Housing Element Update

Final Environmental Impact Report
Responses to Comments on the Draft EIR

SCH#2022060323

June 2023

Figure 4.1-5a GUE-2 Looking North from Laughlin Road

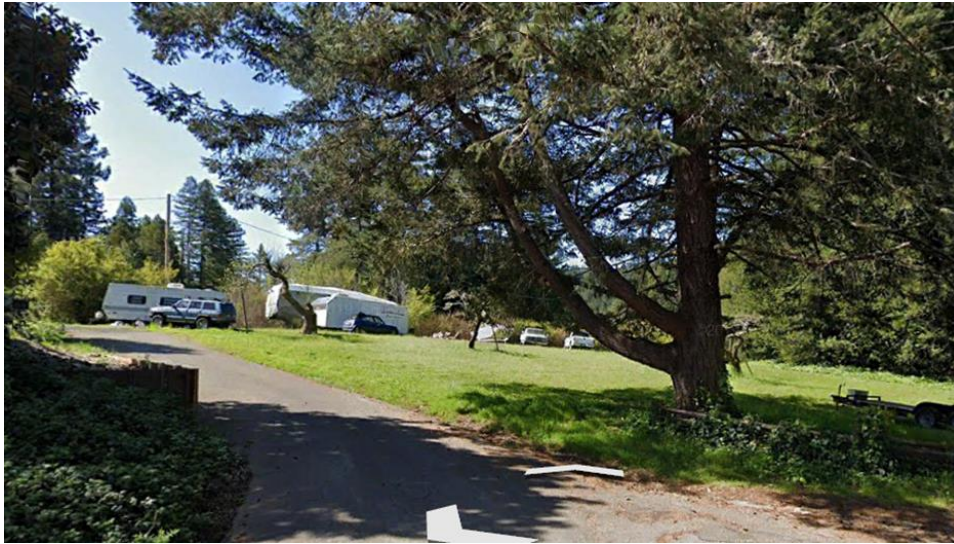
It is unclear which property the commenter is referring to; however, we presume that the commenter resides on Site GUE-2. Figure 4.1-5 on page 4.1-12 of the Draft EIR, and the preceding text describing Figure 4.1-5 on page 4.1-11 of the Draft EIR, have been revised as follows:

GUE-2 and GUE-3 are on largely undeveloped lands among single-family residences bordered by agricultural lands and wooded hillsides (Figure 4.1-5a and Figure 4.1-5b).

Page 2-17, Figure 2-9:

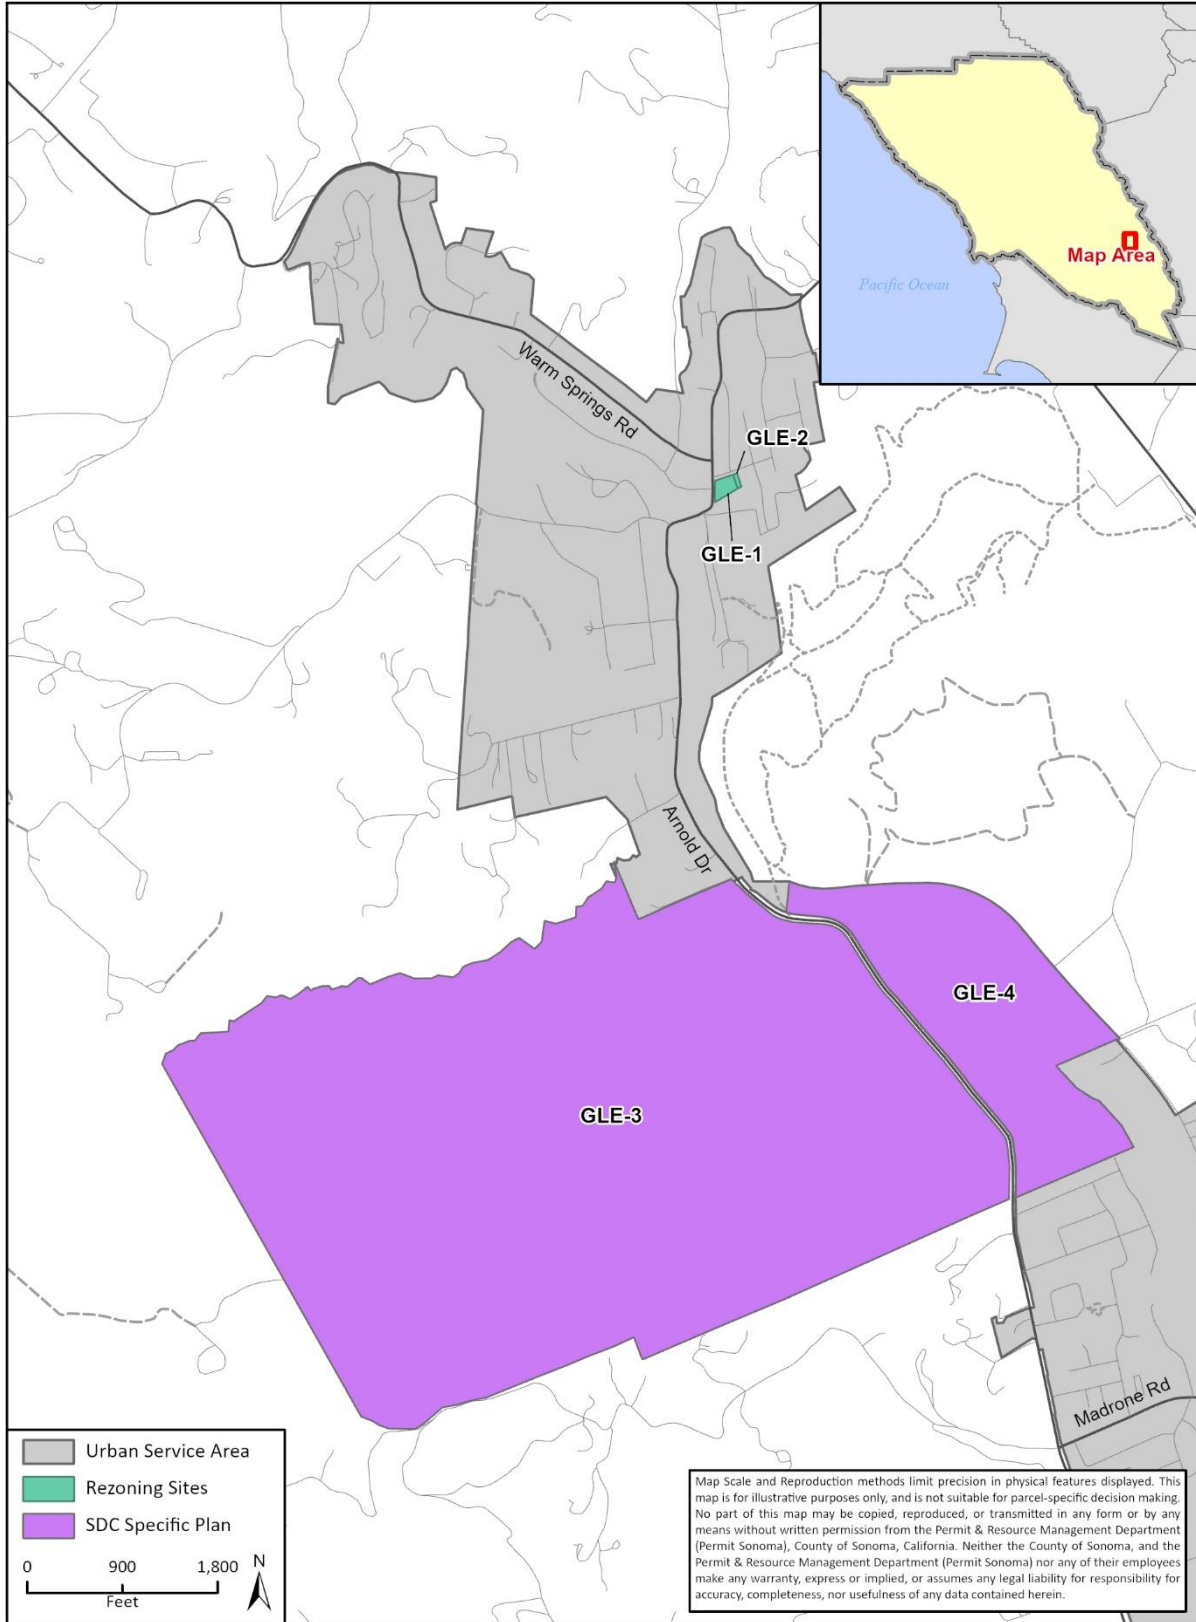
As shown in Figure 2-9 on page 2-17 of the Draft EIR, Sites GLE-1 and GLE-2 are within a designated Urban Service Area. Additionally, page 2-6 the Draft EIR has been revised for clarity, as there was a typographical error:

Page 4.10-10, Figure 4.10-4:

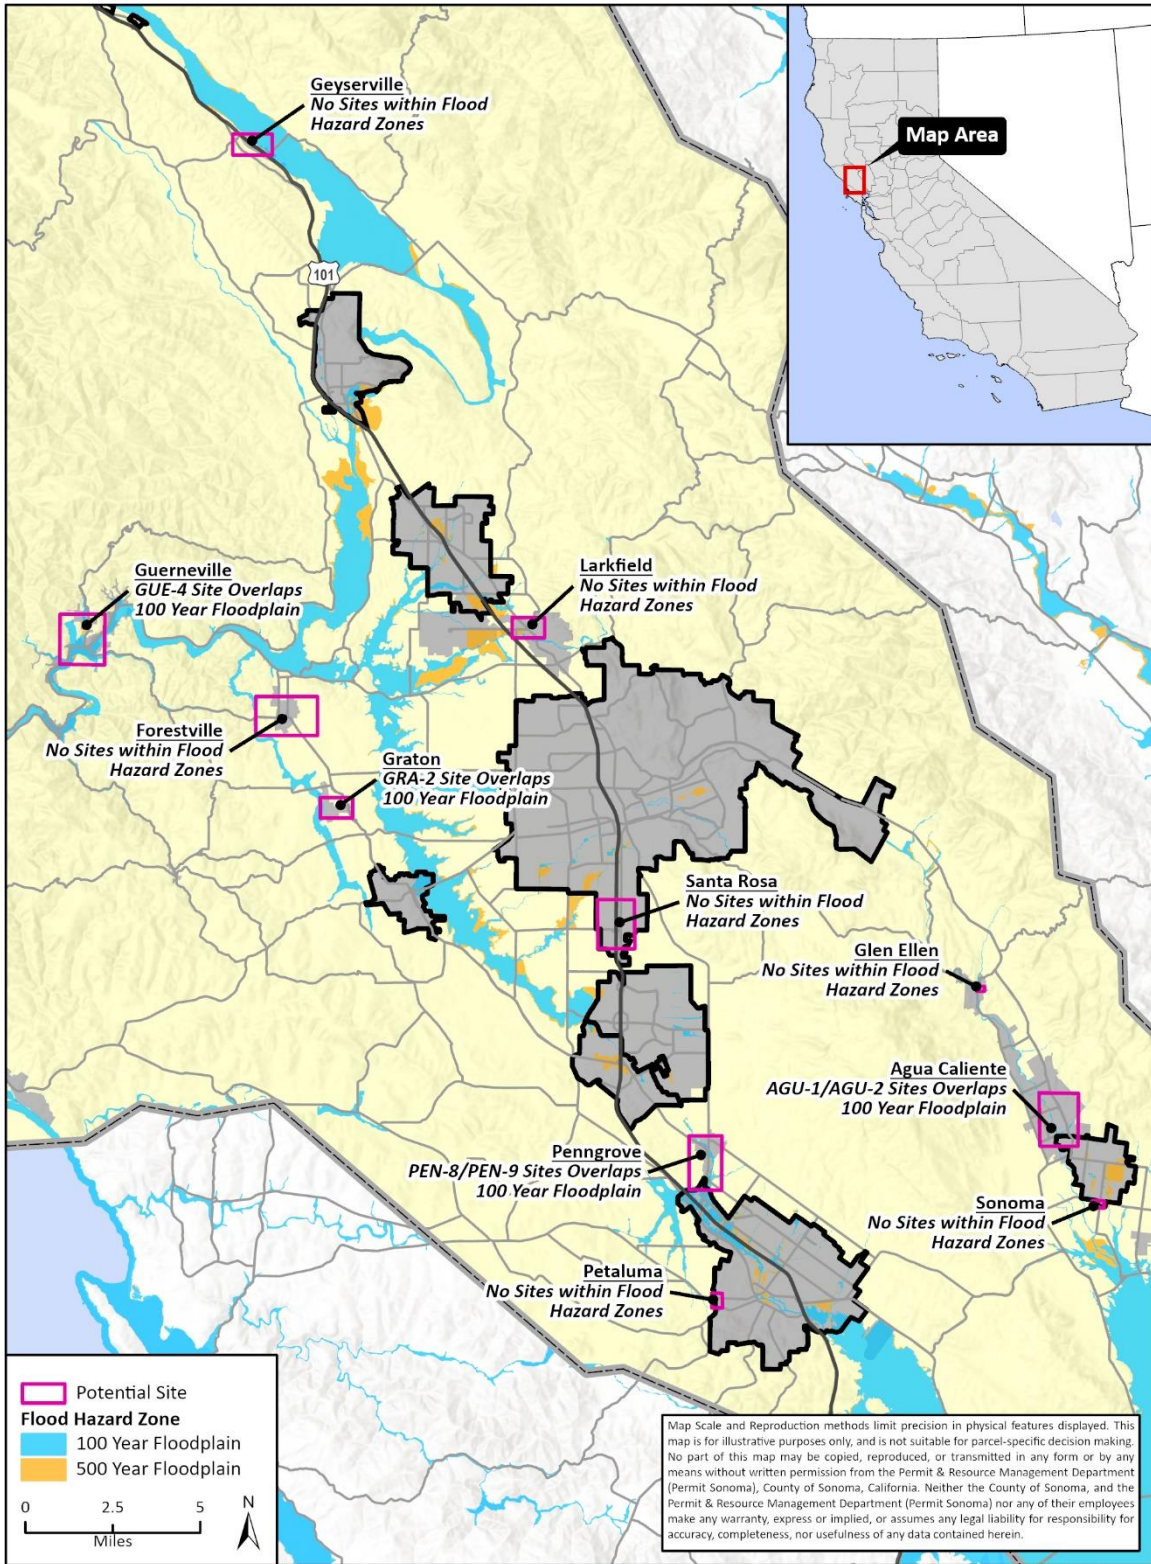
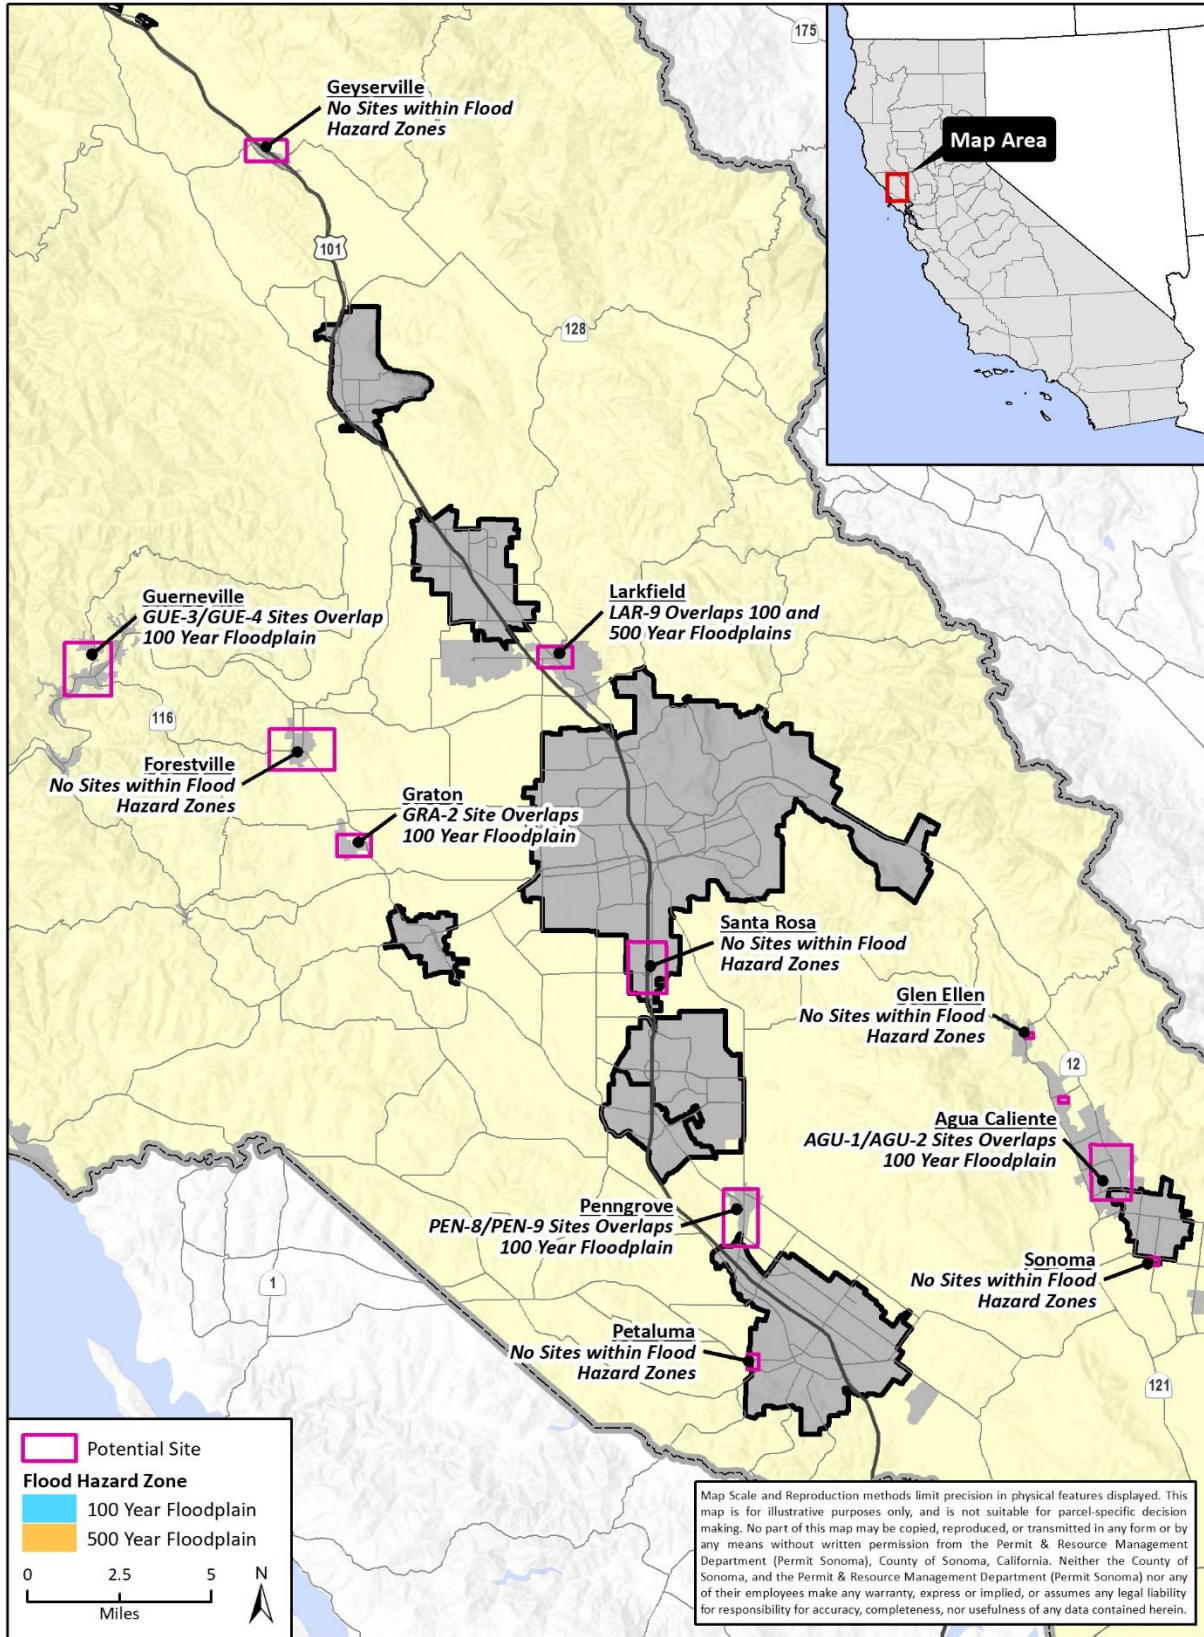
A portion of GUE-3 and GUE-4 is within the FEMA-mapped floodway and an additional portion is within the FEMA-mapped 100-year floodplain, while GUE-2 is outside of FEMA-designated floodplains; refer to Figures 4.10-4 (as revised) and 4.10-5 of the EIR. As discussed under Impact HWQ-4 of Section 4.10, *Hydrology and Water Quality*, of the EIR, development in the 100-year floodplain would be required to comply with General Plan policies that aim to achieve General Plan Goal PS-2. This includes the prohibition of fill in County-identified special flood hazard areas (refer to Section 7B-12 of the Sonoma County Code of Ordinances), and requiring review and approval of proposed drainage facilities by Permit Sonoma. Rezoning Sites that are within the Floodway Combining District (F1) or Floodplain Combining District (F2) would be required to comply with County requirements as stated in Articles 56 and 58, respectively, of the Sonoma County Code of Ordinances. These requirements ensure that any development on the Rezoning Sites would result in no net change in the 100-year floodplain. Therefore, increased flooding on adjacent parcels to the Rezoning Sites would not occur because of the project. Impacts related to flood flows would be less than significant.

As shown therein, the following sites are partially within the 100-year floodplain: GUE-3, GUE-4, GRA-2, AGU-1, AGU-2, PEN-8, ~~and~~ PEN-9, and LAR-9.

Figure 4.10-9 FEMA Floodplain Map – Larkfield

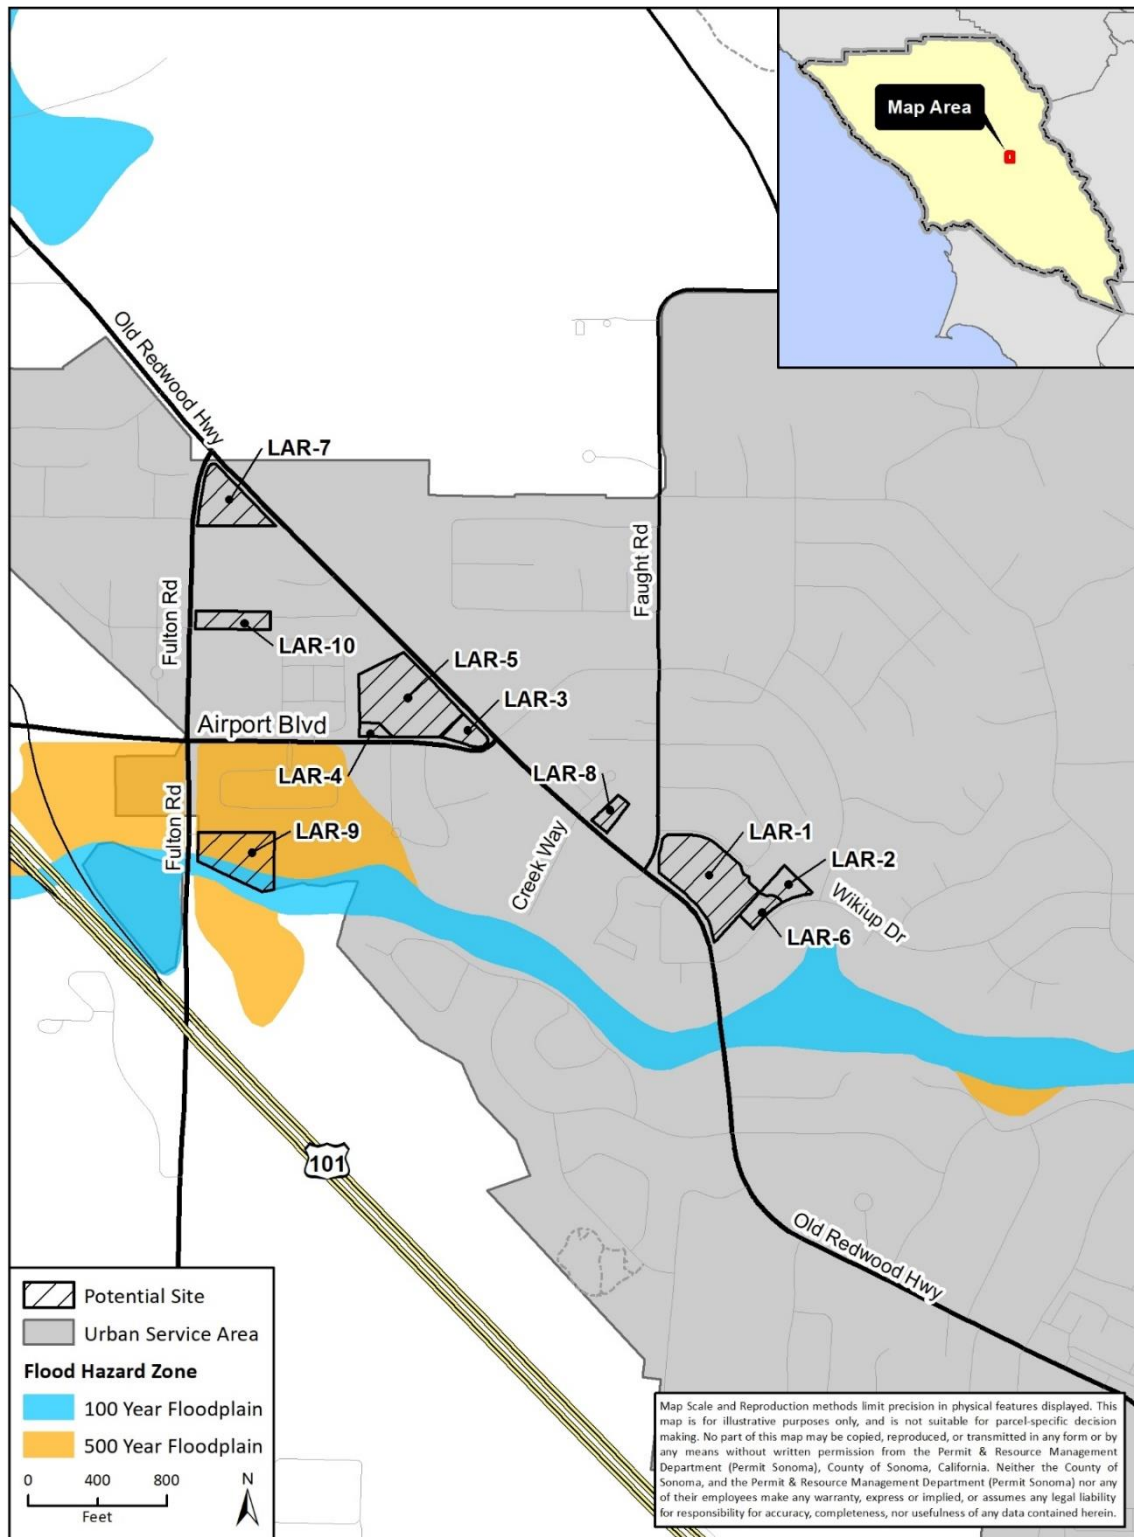
The commenter is correct, and Figure 4.10-9, which shows that LAR-9 is partially within both a 100-year and 500-year flood zone has been added to the Draft EIR. These revised figures are included in Section 5 of this document. Additionally, the following revisions have been made throughout Section 4.10 of the Draft EIR to reflect inclusion of LAR-9 in the flood analysis:

The following figure is added immediately preceding page 4.10-15:
